Subject: OMNIMATE Power male header SU 10.16HP/IT

As part of our ongoing product maintenance and improvement we are going to change the packaging of SU 10.16HP/IT male headers.

Abb.1: old packaging

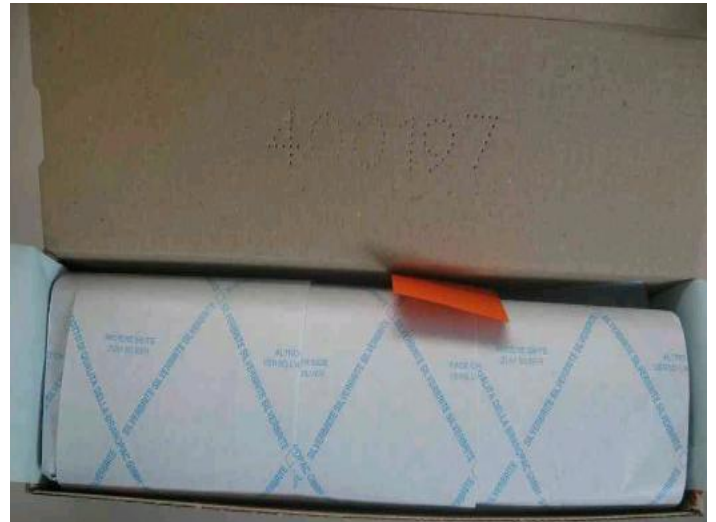
The new packaging concept includes a plastic tray that is vacuumed in a poly bag.

Advantage of the vacuummed packaging:

- Longer storage time of the silver contacts
